**R.I. DEPARTMENT OF ENVIRONMENTAL MANAGEMENT
OFFICE OF WATER RESOURCES PERMITTING SECTION
FRESHWATER WETLANDS PROGRAM
APPLICATION INSPECTION REPORT**

Application No.: 16-0202 **Applicant Name:** DSM Realty Corporation

File Name: DSM Realty Corp (Gold Meadow Farms Solar Array Project)

RE: SSRE RI Gold Meadow Farms
Freshwater Wetland Permit No. 16-0202
RIPDES Construction General Permit Authorization No. RIR101456
Letter of Non-Conformance

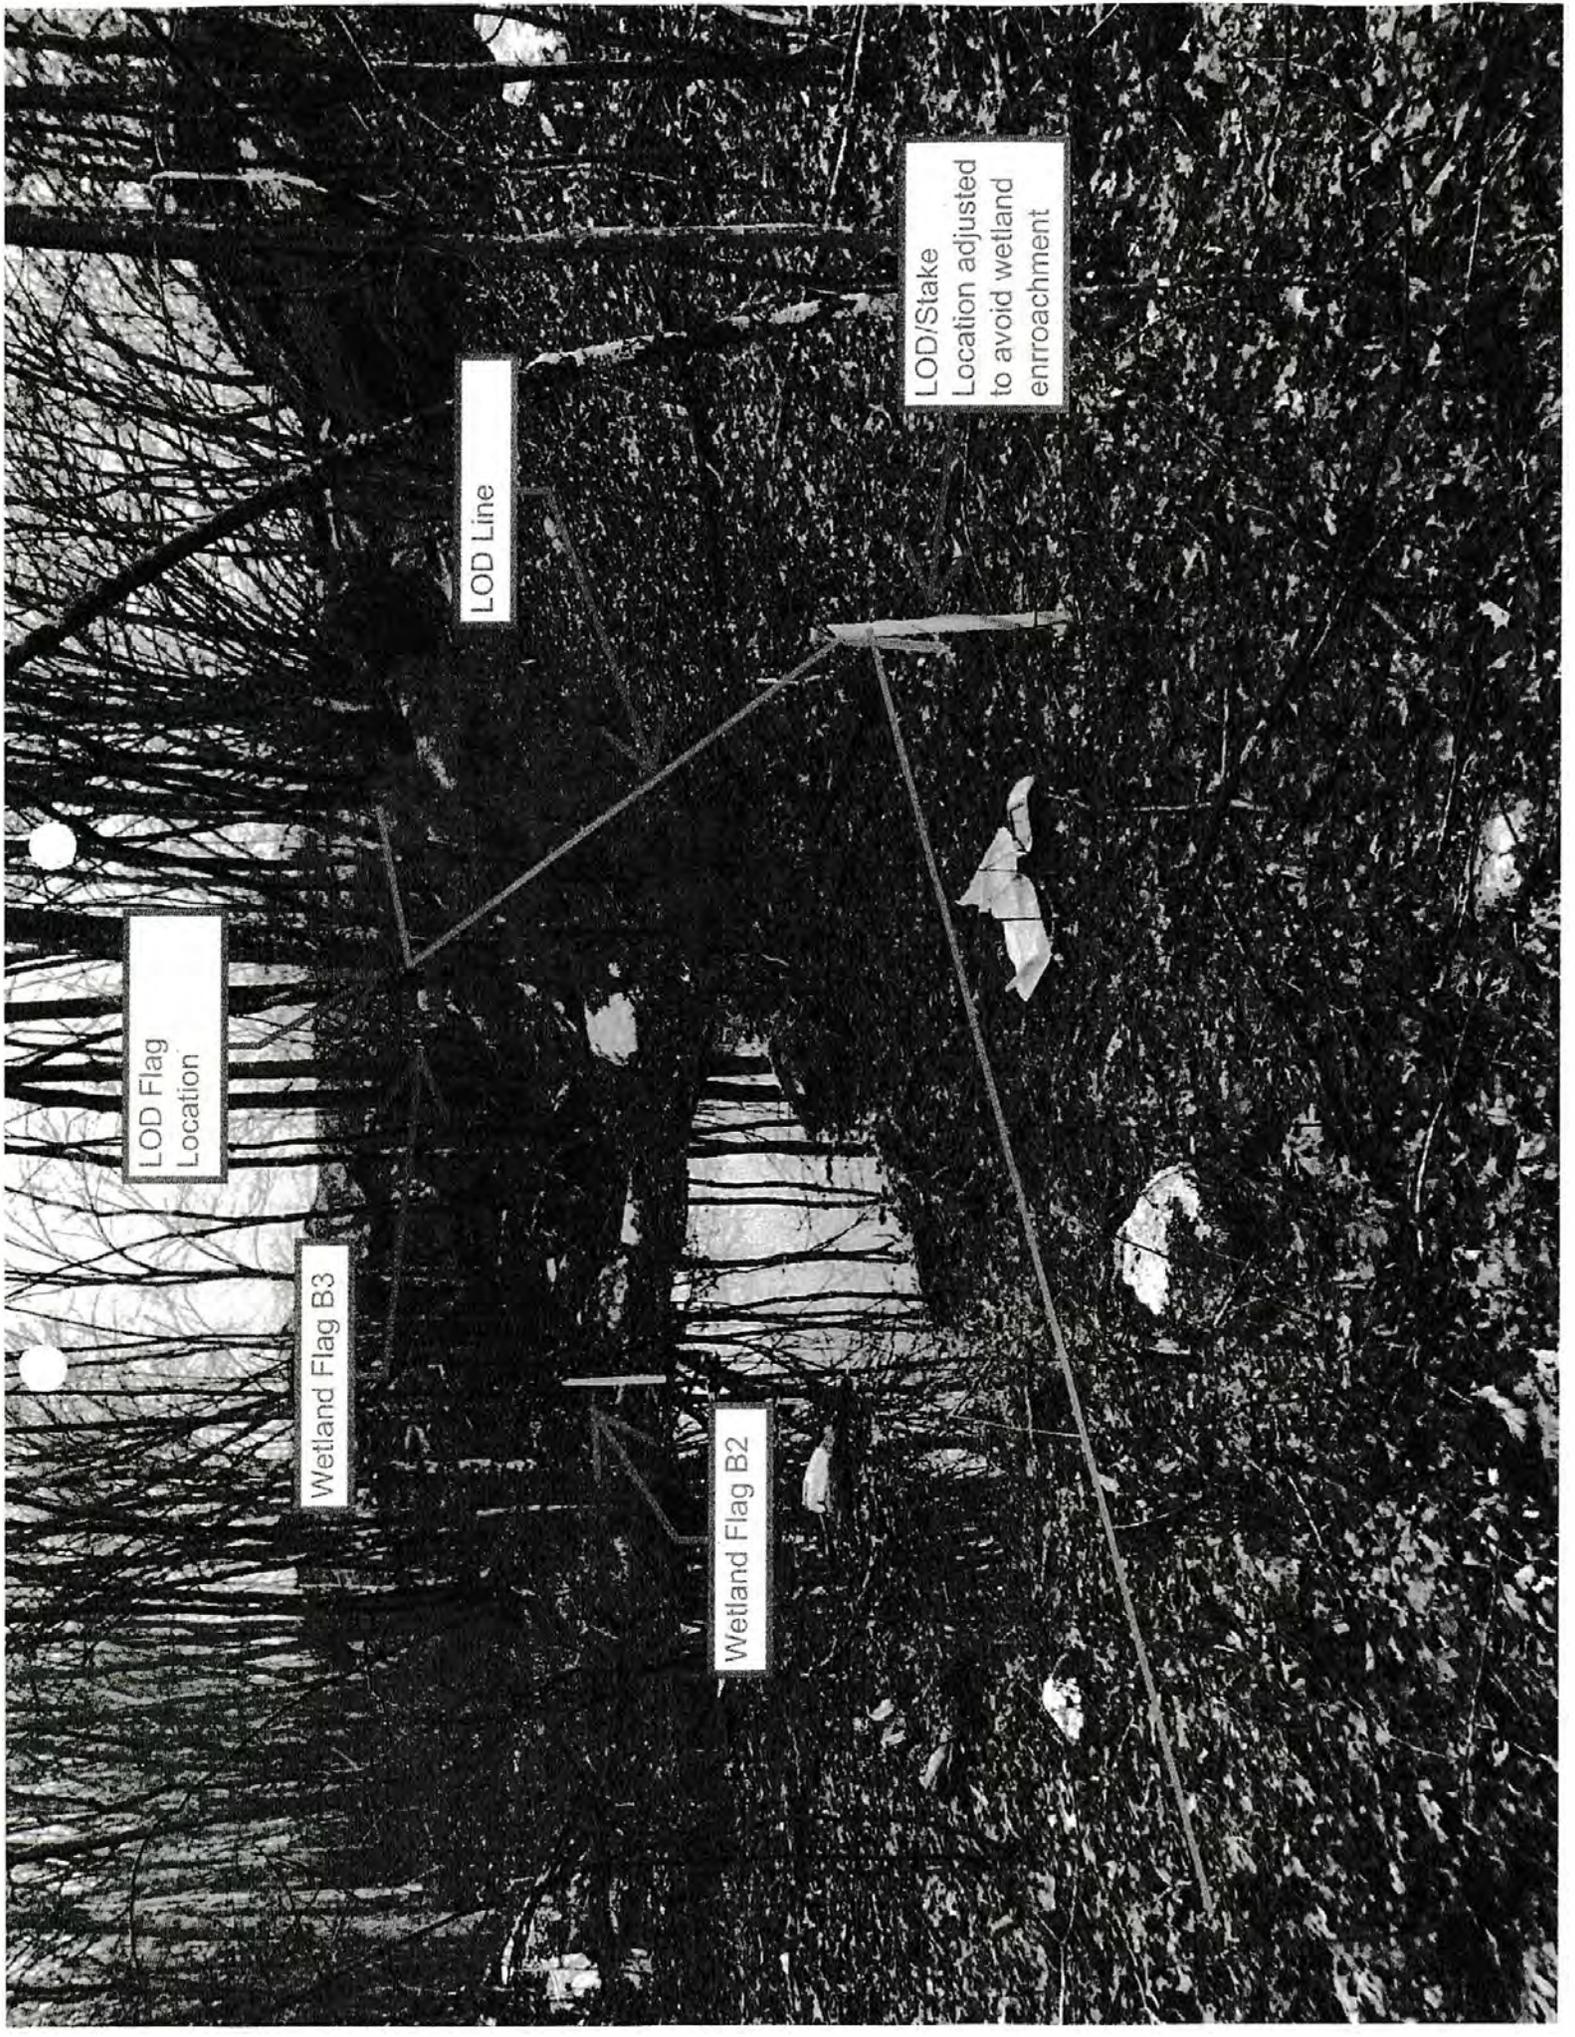
I called Dave Russo of DiPrete Engineering prior to inspection to inquire about whether the culvert had been installed on the access road, since I received a new complaint. He indicated that it has not been installed yet that there were issues pending availability, design, pricing etc. I also called Dave back after the inspection. I asked that if possible LOD stakes 6 and 7 be relocated prior to work out there to ensure that no physical encroachment into Wetland B would occur. He said that they have a surveyor out there tomorrow (2/15) that they would take care of it and make sure that no work occurred there until they could revise the stakes accordingly. I asked about why they even needed to do any further clearing there, that nothing was proposed in this location. He explained that it has to do with the effect of shading on solar panels. Provided they slightly tweak the stake locations to avoid impacts to Wetland B, clearing is outside of wetlands.

LOD/Stake
Location adjusted to avoid wetland encroachment

Photo 4: Entrance to solar array from Lippett Road access road-two new poles recently installed:

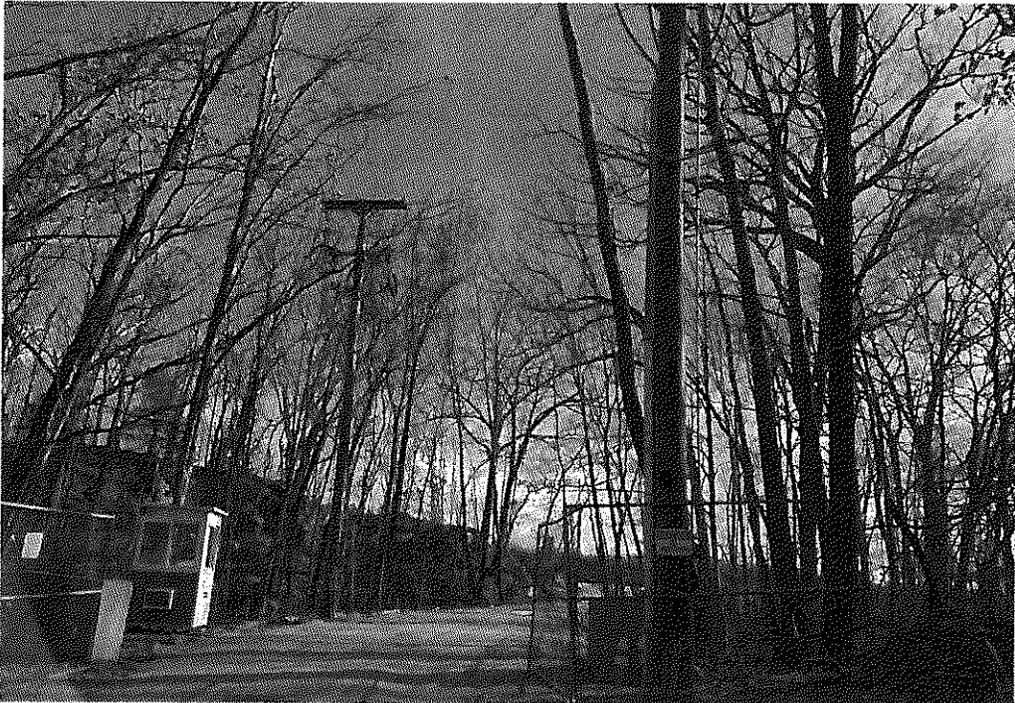
- I drove to the entrance of the solar array. Two new poles have been recently installed on either side of the road (Photo 4), both of which are in close proximity to wetlands and appear to be outside (isolated wetland and perimeter wetland), although measurements were not taken to confirm. It appears that wires are going underground in this area.

Photo 5: recent clearing on south side of access road to solar array:

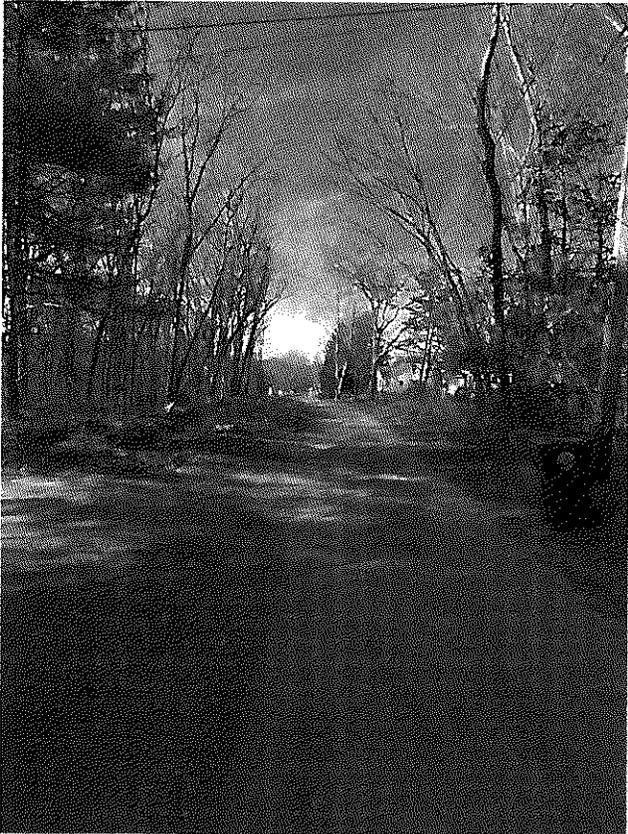
- The south side of the access road has been cleared (Photo 5). It should be noted that a vegetated wetland is present further down slope in the adjacent interior woodland south of road. It was also noted that the ASSF culverted underneath the access road was not flowing at the time of inspection.

Photo 9: Eastern side of Wetland F, some new erosion control reinforcements:

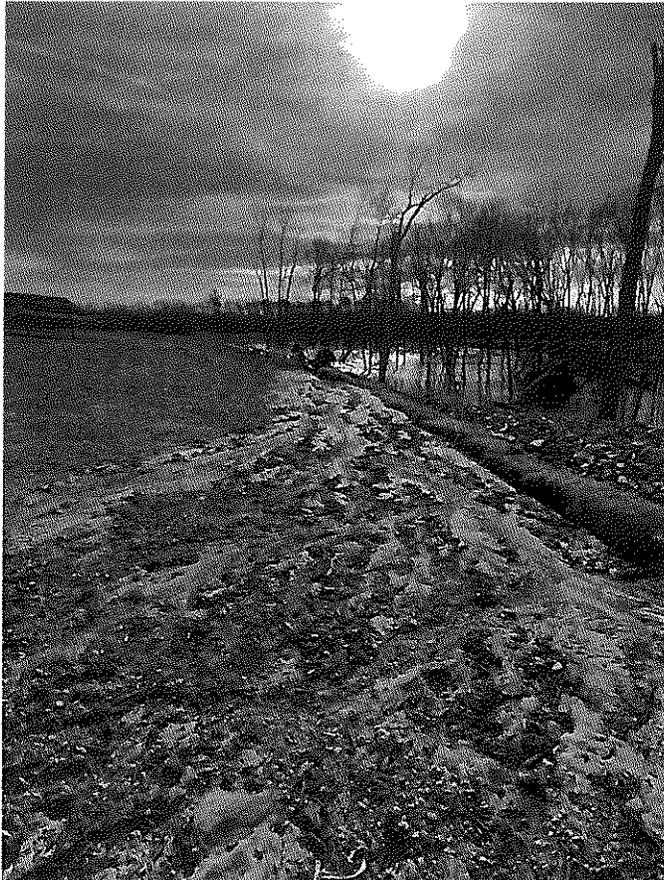
- Wetland E also remains flooded, but not to the extent of Wetland F. Perimeter fencing adjacent to the gravel travel way between Wetlands E and F has been installed. The bottom approximately 6-8 inches has been removed as suggested in the permit letter. Portions of the wattles along the road should be reinforced where no longer functioning.
